**City of Margate
DEVELOPMENT REVIEW COMMITTEE
Application for Site Plan**

Project Name Dollar General at Margate		DRC # 09-15-01
Address SE Corner of State Road 7 and SW 7th St		
Acreage 1.8	Folio Number 4942-06-18-0930, 4942-06-18-0931, 4942-06-18-0932	Paid: \$ 250.00
Existing Use Vacant Lot		
Legal Description Serino Park Sec 3 81-46 B Tr B S 67.81 of N 432.62,		
SERINO PARK SEC 3 81-46 B TR B N 300		
SERINO PARK SEC 3 81-46 B TR B,S 67.81 OF N 367.81

**Reference: Dollar General at Margate
SE Corner of State Road 7 and SW 7th St
DRC No. 07-15-03
PID#s 494206180930, 494206180931, and 494206180932**

1st Round of comments – Development Plan Review

BY:	FG
DATE:	06-18-15
REVISION/ISSUE:	CITY OF MARGATE DRG COMMENTS
NO.:	1
ENGINEER'S NAME & PER	JASON D. BILLARD, P.E. P.E. LICENSE NO. 73800
PROJECT #	215.004
DATE	06/25/2015
SHEET	DP1.0
SCALE	1:20
DEVELOPMENT PLAN

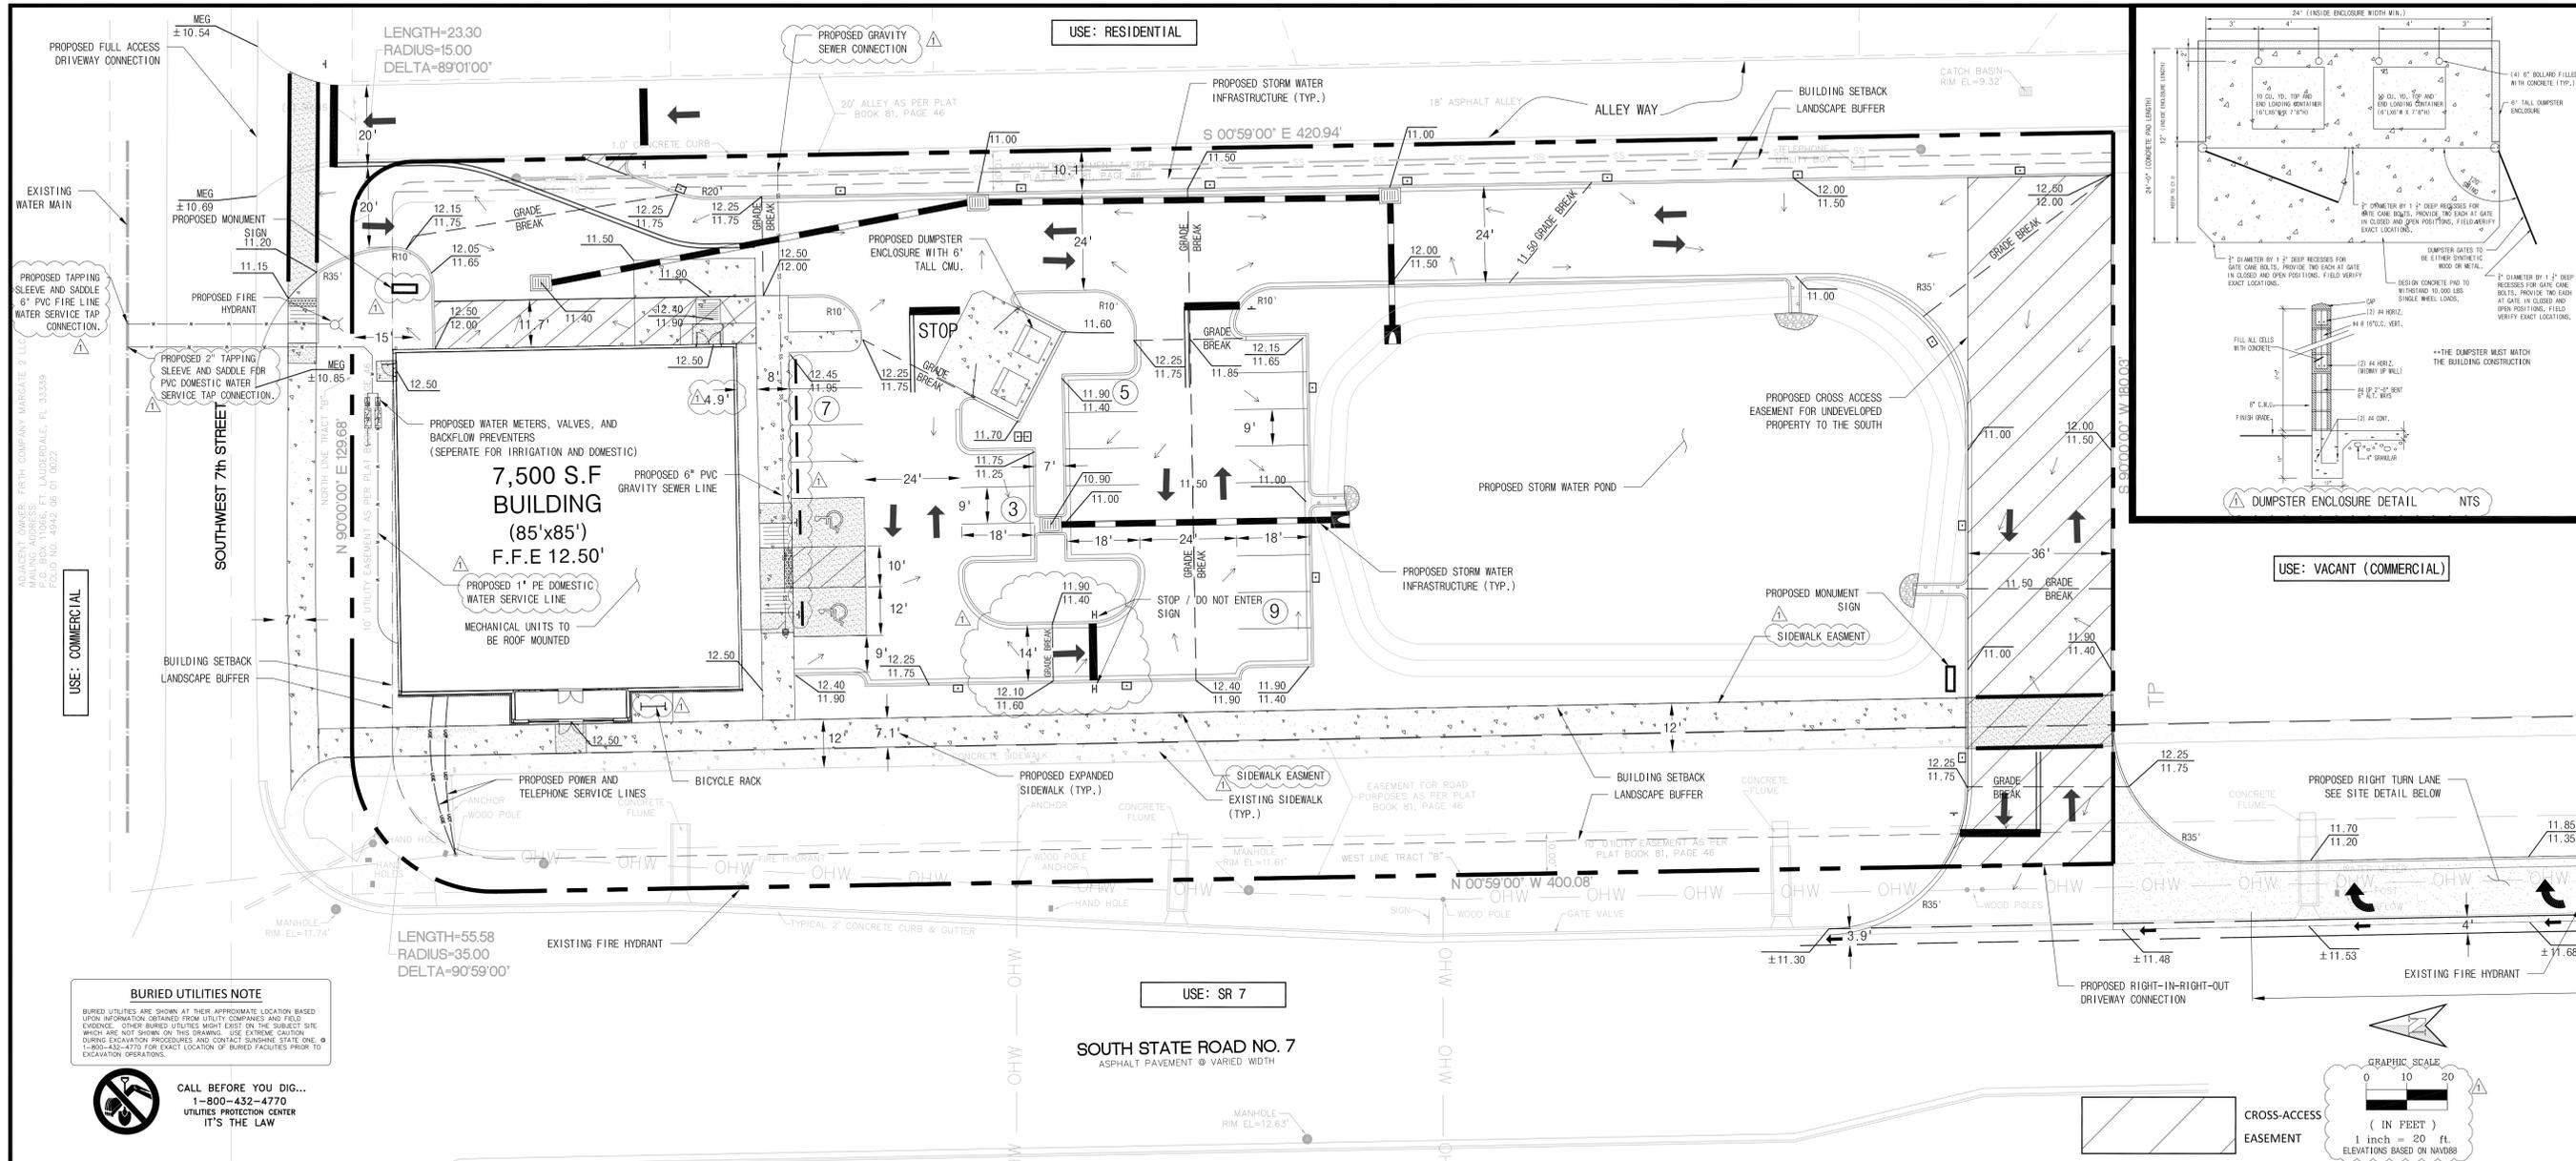
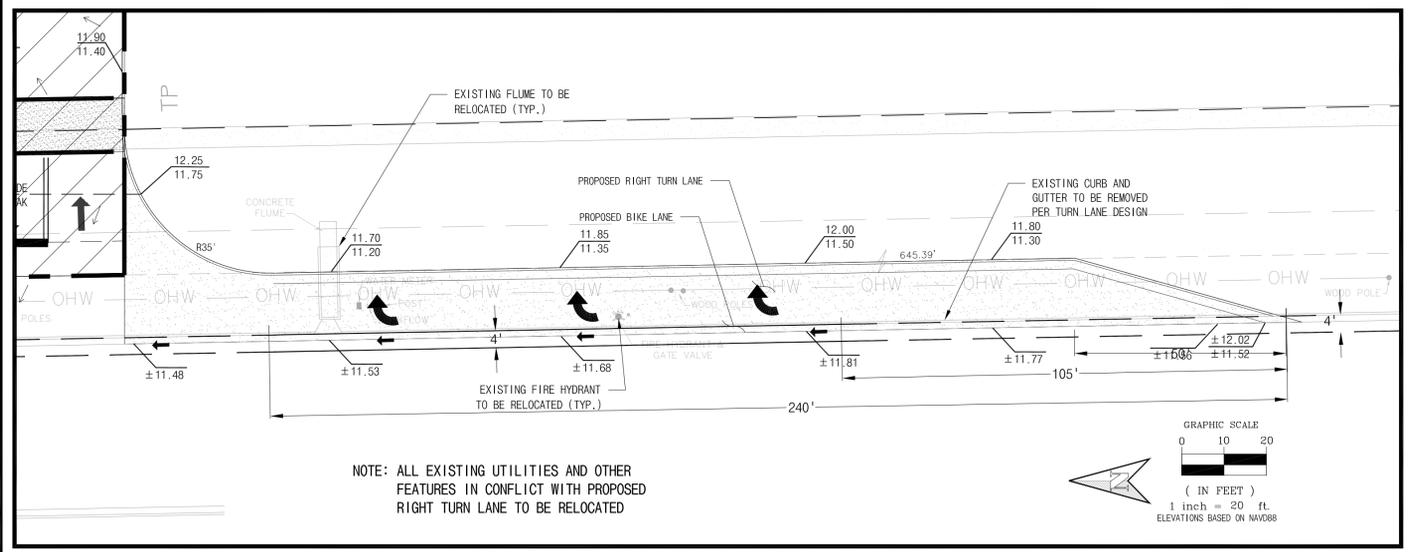
Comment 1: The two dead end parking bays should be revised to have connectivity between the two for better traffic circulation.

Comment 5: The applicant is required to connect the proposed gravity sewer service connection in-line to the existing gravity sewer service line, and not to the manhole as currently proposed.

Comment 7: Show the type and size of connection and the type of piping material for the water line on SW 7th St.

Comment 8: Domestic water service shall be metered separately from irrigation and/or fire service.

Comment 9: An easement for the sidewalk will be required.

Comment 10: The building will need to be shifted north slightly and can be within eighteen inches of the 10-foot utility easement line.

Comment 14: Add a detail of the dumpster enclosure which includes height, materials, etc., as well as an approval letter from Waste Management.

Comment 16: Parking is calculated at 3 stalls per thousand square footage of non-storage area.

Comment 17: Wheel stops are required in all the parking spaces abutting the walkway.

Comment 18: Bicycle parking is required per Section 9.12.E6.

Comment 19: Parking in the second lot layer is discouraged by the City Code and is limited to no more than 20 percent of the lot width.

Comment 21: The pedestrian zone requirement requires a four foot landscape relief between the sidewalk and the building.

Comment 23: An eight foot landscape buffer and then a seven foot sidewalk is required on SW 7th St.

Response 1: The site layout has been updated to eliminate the dead end parking; please refer to sheet DP1.0.

Response 5: The gravity sewer connection has been updated to reflect an in-line connection to the existing gravity sewer as requested; please refer to sheet DP1.0.

Response 7: The size, type, and piping material of the connections has been added to the plans. Refer to sheet DP1.0.

Response 8: Per the engineering department's request, the domestic water line and the proposed water line to the fire hydrant will be separate taps to the water main. The domestic water and irrigation service will have separate meters; please refer to sheet DP1.0.

Response 9: An easement line has been added to the rear of the proposed expanded 12' sidewalk running along State Road 7; please refer to sheet DP1.0.

Response 10: The building has been shifted as requested; please refer to sheet DP1.0.

Response 14: A detail of the dumpster has been added to the plans; please refer to sheet DP1.0. A copy of the Waste management letter was included with the initial submittal. An additional copy of the e-mail correspondence is attached with this letter.

Response 16: Acknowledged, the site data table has been updated with the parking based off the sales floor area; please Refer to sheet DP1.0 for the updated parking calculation.

Response 17: Wheel stops have been added to all spaces abutting a walkway; please refer to sheet DP1.0.

Response 18: A bicycle rack has been added; please refer to sheet DP1.0.

Response 19: Due to the depth of the site parking in the second layer will be required, however the revised site plan meets the 20 percent parking criteria in the second layer per City Code; please refer to DP1.0.

Response 21: A 4 foot pedestrian zone has been added between the building and the sidewalk as requested; please refer to sheet DP1.0.

Response 23: An 8' buffer and 7' sidewalk is proposed off of SW 7th street as required; please refer to DP1.0.

PROJECT #	215.004
DATE	06/25/2015
SHEET	CP1.0
SCALE	1:20
PHOTOMETRIC PLAN

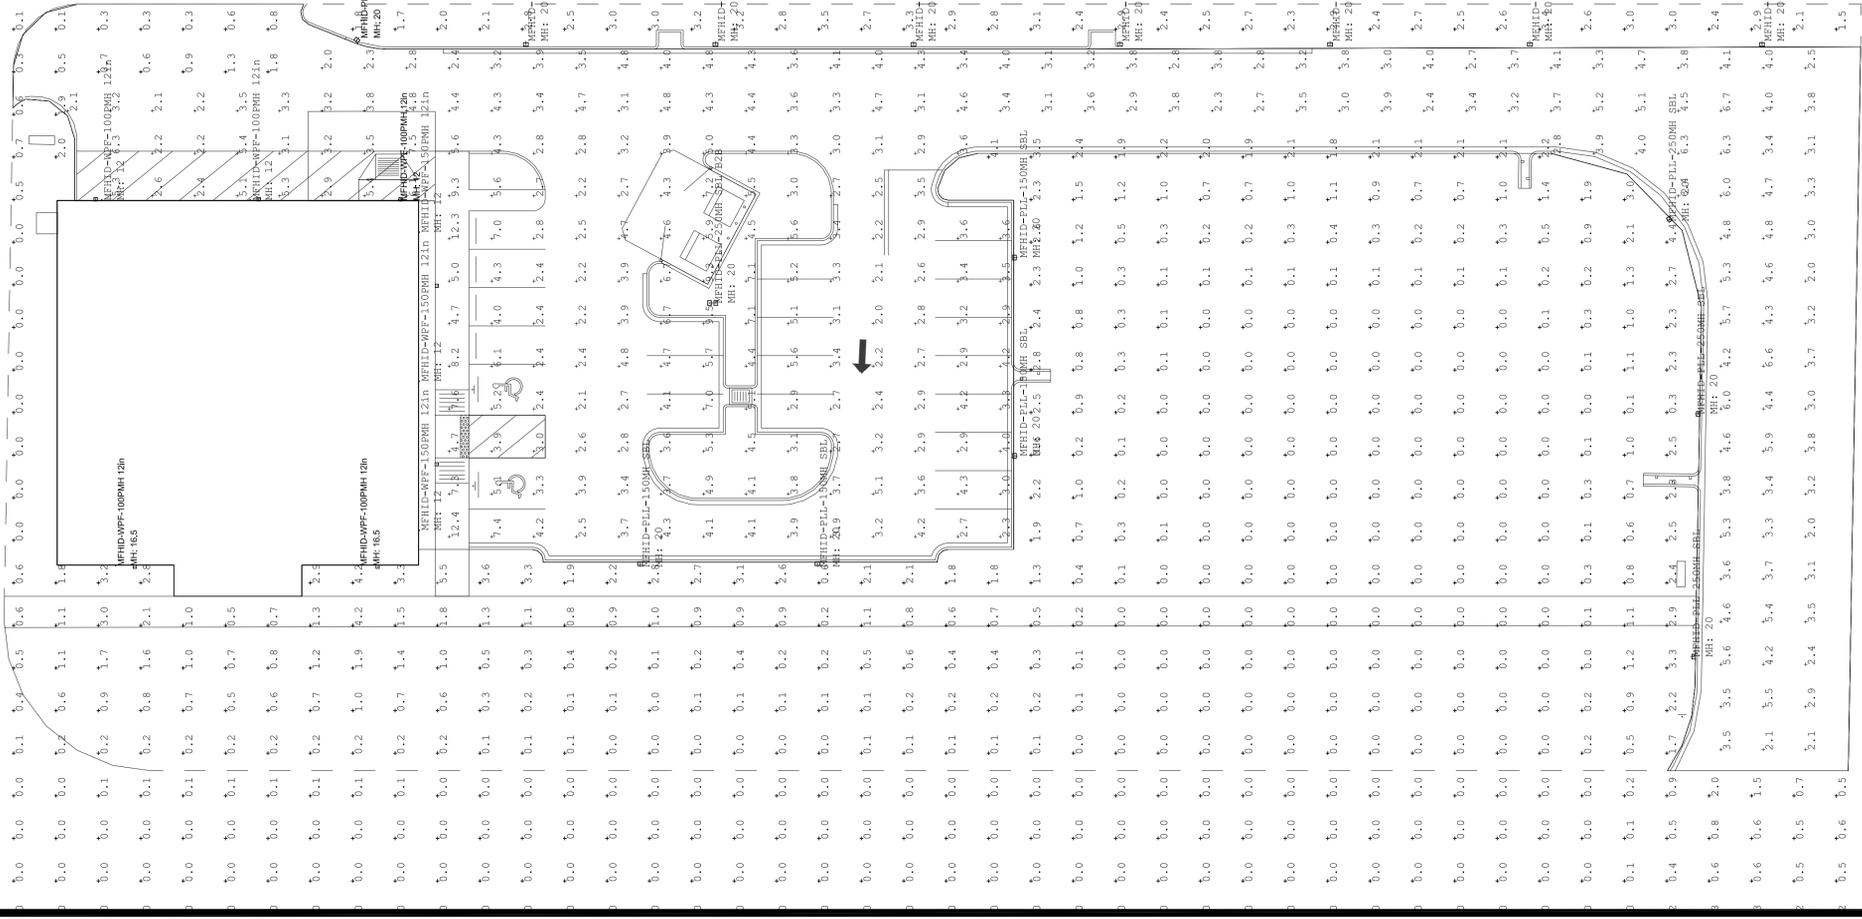
Comment 12: The photometric plan shows lighting for level one activity which is allowed for businesses which close at 7:00pm. For businesses open later than 7:00pm, the lighting must be a minimum of two foot-candles in the vehicular use area. Please also include a specification of the light fixtures on the photometric plan as the Code requires fully shielded fixtures.

Response 12: The photometric plan has been updated to meet the code requirements listed above. The specification sheets have been added to this plan set; please refer to sheet CP1.0 and CP1.1.
